DELEGATED APPLICATION REPORT

App Ref: PL/26/0601 Householder planning permission

Address: 28 Coldicutt Street, Caversham, Reading, RG4 8DU

Proposal: Retrospective permission for the demolition of an outbuilding and erection of a replacement outbuilding

Figure 9 - Internal view of independent rear portion of proposal, showing low power sockets

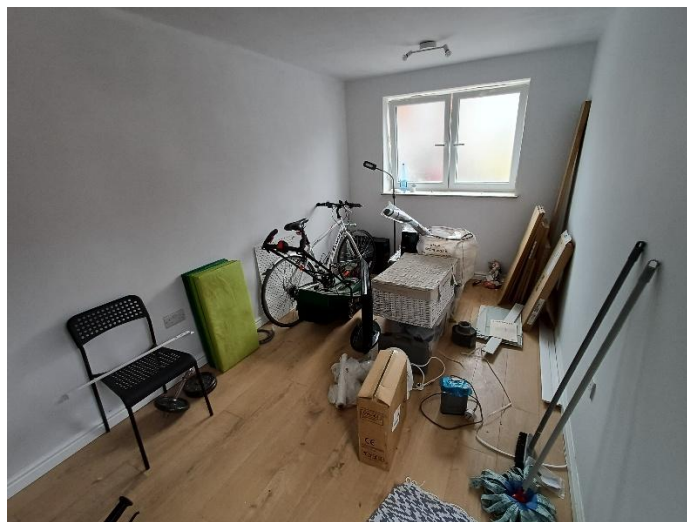
7.1.3 The measures proposed, may mitigate the risk of flooding on the future users. However, it is clear that the installation of some electrical services are below the flood level identified (clearly externally), it would appear the services are run through the main house to the proposal. The construction methodology is also not clear, and on the basis that other flood mitigation measures have not been implemented, there is no certainty that the development has been constructed in line with the mitigation measures proposed within the flood risk assessment. In addition, the provision of a new dwelling, with overnight sleeping, within an area of high risk of flooding, would introduce a sensitive use into a flood zone. It is possible that due to the high flood risk, there may be more limited warning in a flood event, and there would be a high risk that inundation could occur whilst occupants are sleeping. In addition, given a lack of escape routes, and flood levels of 1.32m, the entire property (outbuilding) would be flooded, and would likely result in damage to all items within the building, and would displace an occupant for an extended period of refurbishment and repair. Whilst moving to an upper floor may be appropriate for an incidental building, given the ease at which the rear could be separately let, and access to the main house removed (through locking of an external gate), it would not appear possible for future occupants to shelter at first floor within the main building.
